INDESIT company

Model type:
WIL85EXBG

Commercial code:
F033598

n1040381: Drain pump with bayonet-style filter - front Loading Brembate

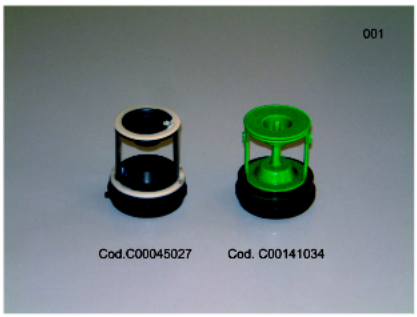
From serial no. 50720.0001 a new drain pump with bayonet-style filter has been installed on all front loading washing machines manufactured in Brembate.

New parts:
C00119307 - Drain pump
C00141034 - Pump filter kit

Premodification parts:
C00092264 - Drain pump
C00045027 - Pump filter kit

The new parts can be used instead of premodification ones.
